CERTIFICATE OF APPROPRIATENESS

Property: 532 Granberry Street, Lot 8, Block 2, Freeland Subdivision. The property includes a historic 1,455 square foot, one-story wood frame single-family residence and detached noncontributing metal outbuilding situated on a 4,935 square foot (47' x 105') square foot corner lot.

Proposal: Alteration – Construct a one-story addition at the rear of the existing historic structure. The project will also include the following work:

HAHC Action: Approved

WEST ELEVATION – FRONT FACING GRANBERRY STREET

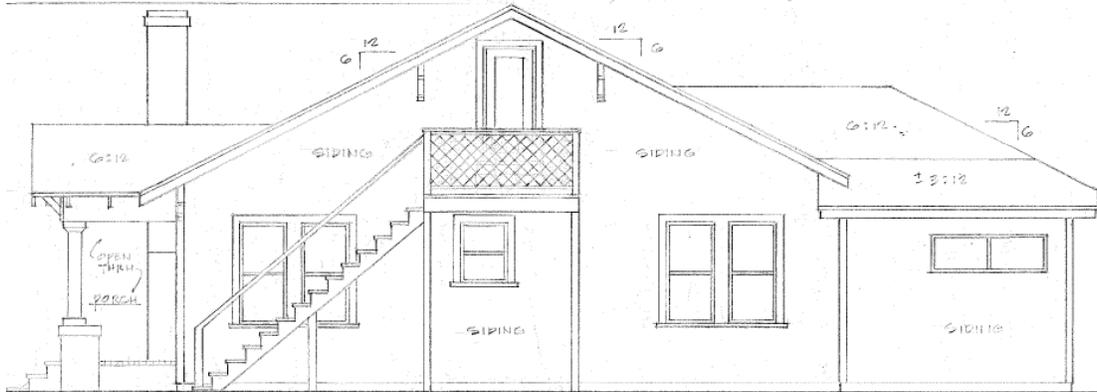
**Front Elevation:** The existing front elevation of the residence features a front porch on the southern portion of the façade. Low brick piers topped by square columns support a front gable roof. To the north of the front porch is a large stucco chimney flanked by two windows. A small bump-out, located to the north features a window. To the south of the original structure is previously constructed addition with a single window. A non-original exterior staircase leads up to a second-story deck.

The previously constructed addition to the south will be removed, along with the non-original exterior staircase and second story deck. The house will be raised between 8"-10". The brick piers will be raised to keep the existing height of the columns. The non-original windows flanking the chimney will be reduced in width by 6" to better maintain their original proportions. The non-original sidelights will be altered with wood panels. See drawings for more detail.

**SOUTH ELEVATION  
EXISTING**

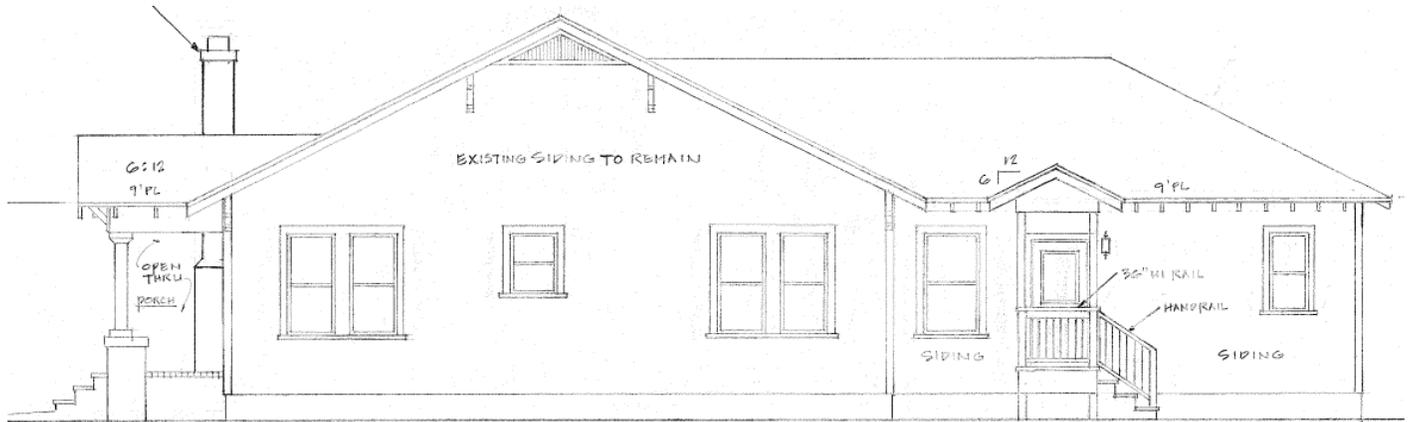
**Side Elevation:** The existing south elevation features the side profile of the front porch followed by a pair of windows, a single window, and another pair of windows. At the rear is the previously constructed addition with a pair of horizontally oriented windows. A non-original exterior staircase and second-story deck spans the front two-thirds of the original structure. A non-original door is located in the gable.

The non-original exterior staircase and second-story deck will be removed. The gable door will be removed and sided over. The previously constructed addition will be removed and a new addition will be constructed. The new addition will have a covered side entrance with a window on either side. See drawings for more detail.

**NORTH SIDE ELEVATION**

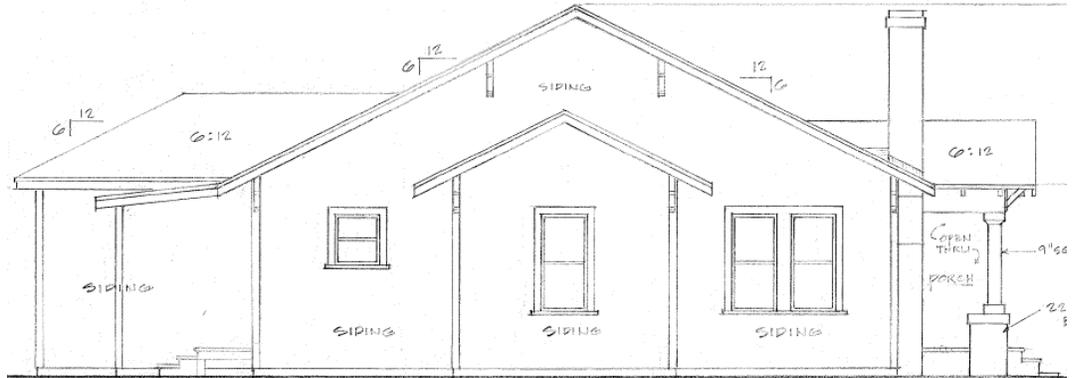
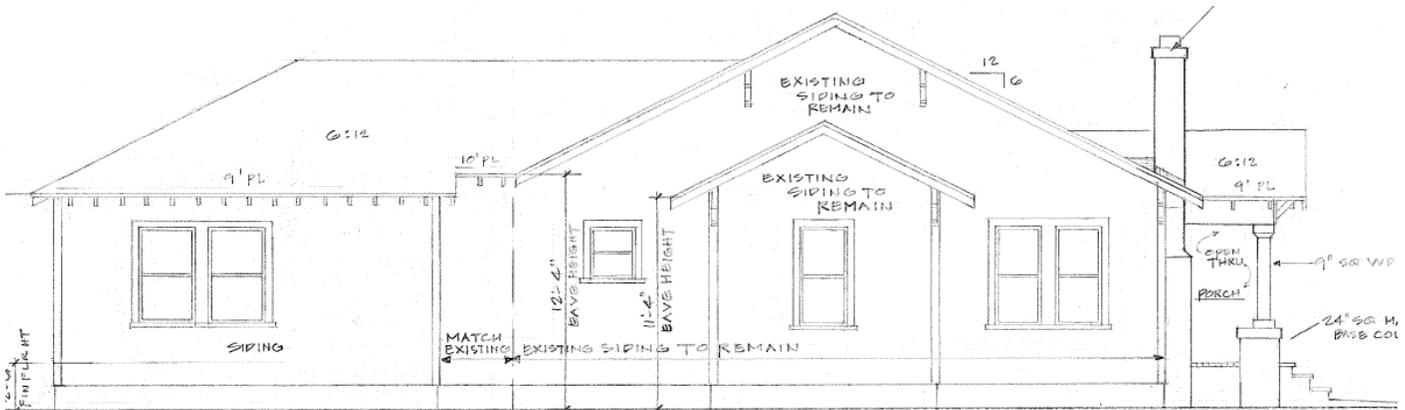
**Side Elevation:** The existing north elevation features the side profile of the front porch followed by a pair of windows, a single window in the side bump-out, and another window. At the rear is the previously constructed addition and a covered area with a shed roof.

The previously constructed addition will be removed and a new addition will be constructed. The new addition will have a pair of windows towards the rear. See drawings for more detail.

EAST (REAR) ELEVATION

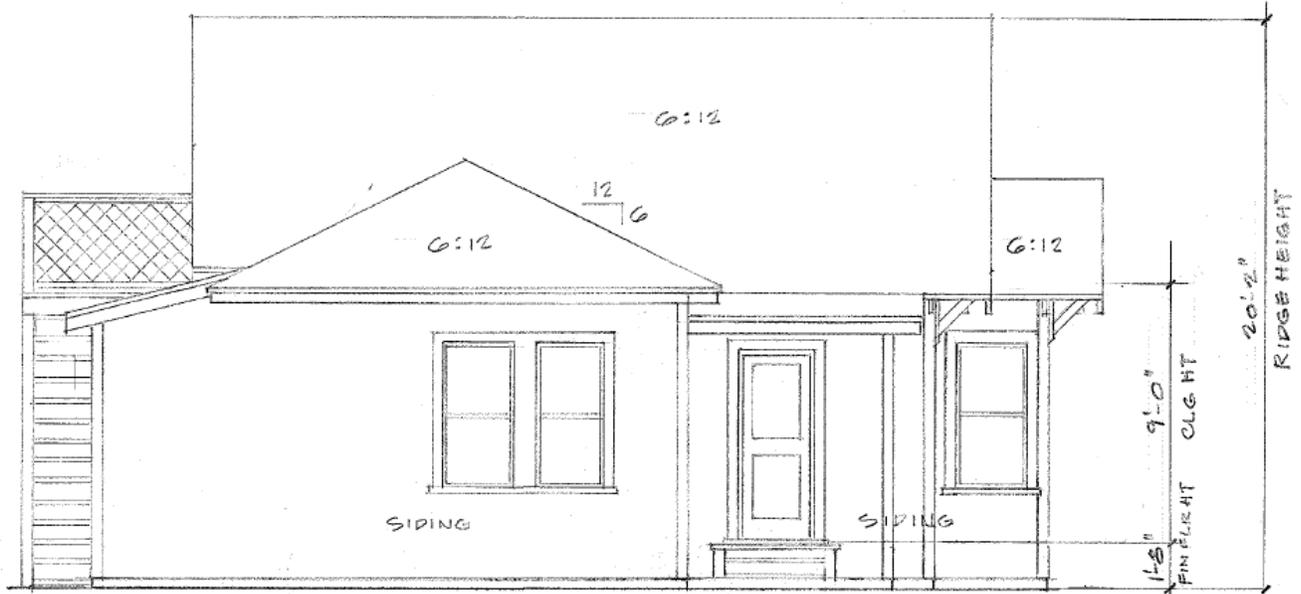
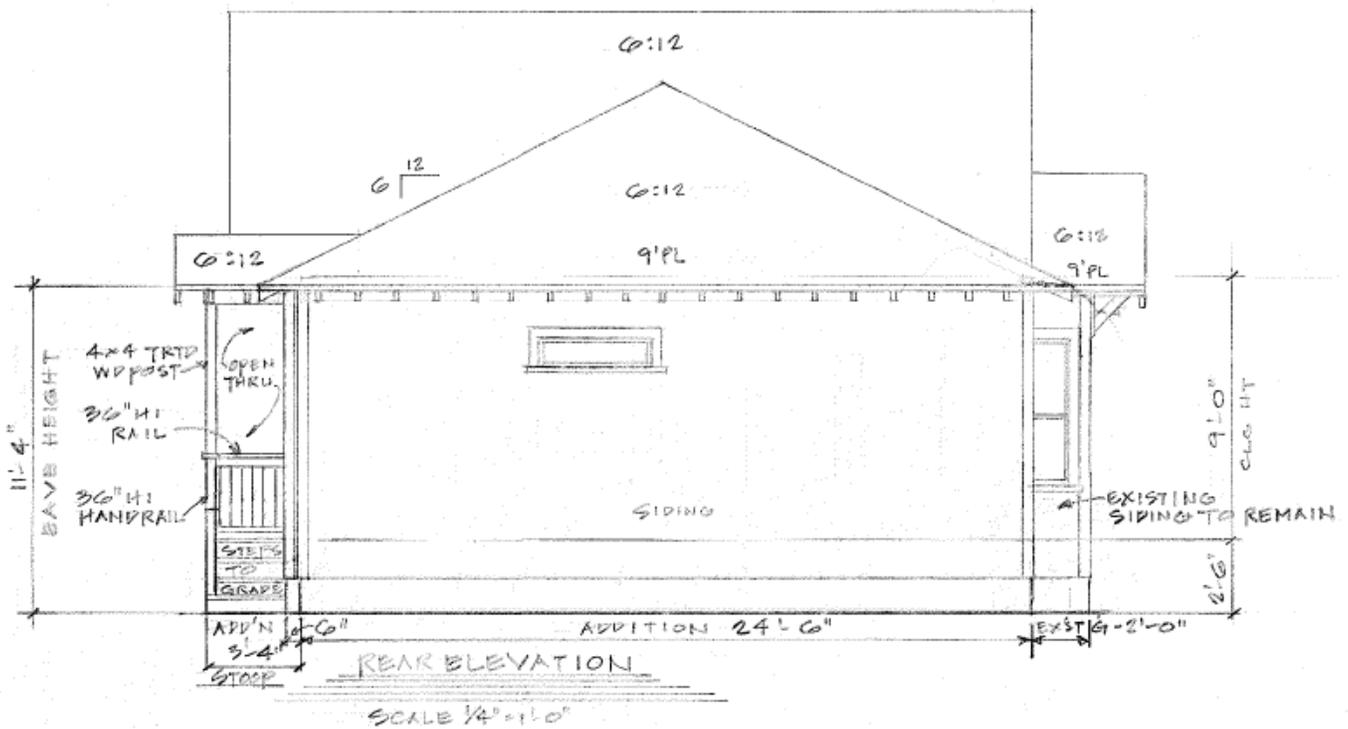
**Rear Elevation:** The rear elevation of the residence and addition is not visible from the public Right-of-Way. See drawings for more detail.

**ROOF PLAN**  
**EXISTING**

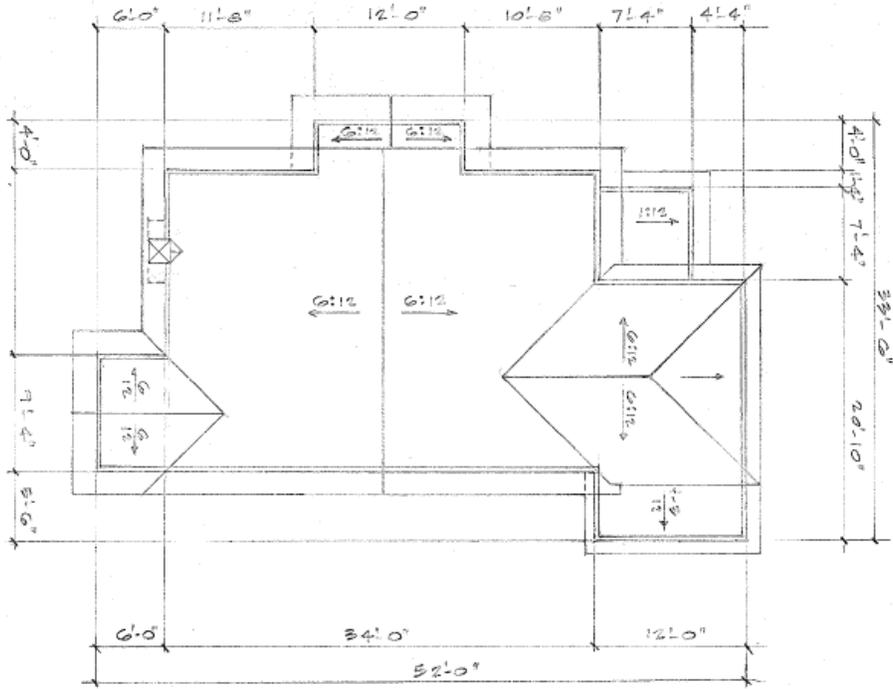
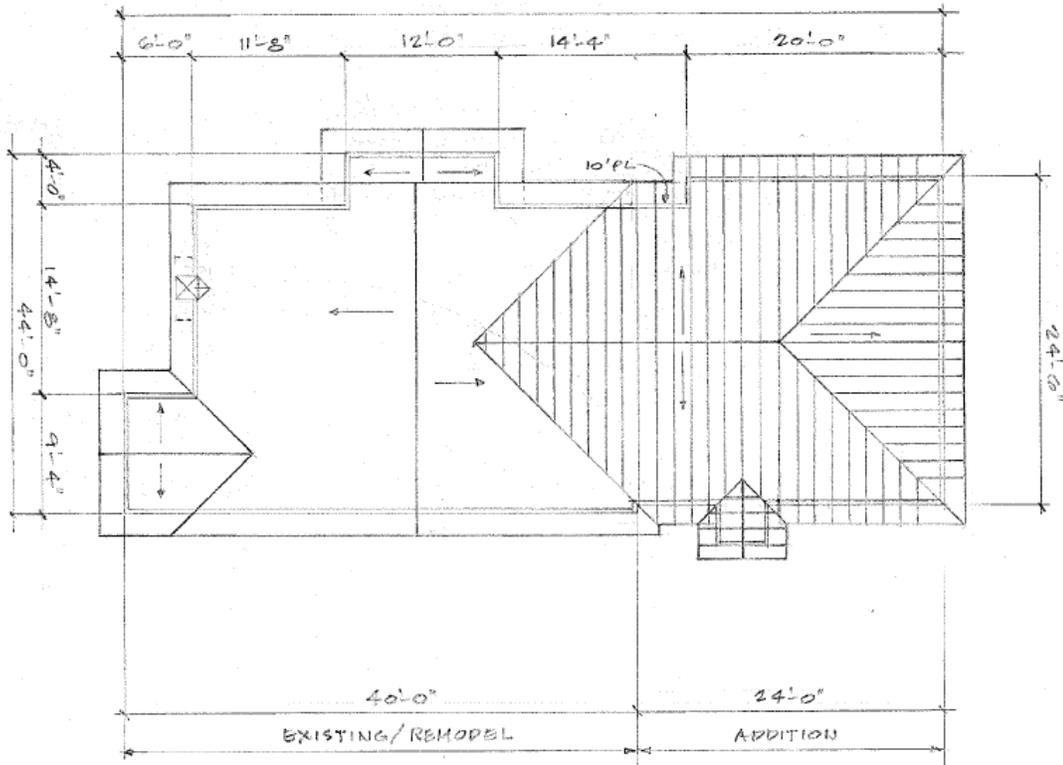
**Roof:** The existing composition shingle side gable roof has an eave height of 10'-6" and a pitch of 6:12. Since the house will be raised, the eave heights on the original structure will be increased. On the north elevation, where the addition connects to the original structure, the eave height will be 12'-4". All other eave heights will be 11'-4" to match existing (raised). The roof pitch of the addition will be 6:12 to match existing. See drawings for more detail.
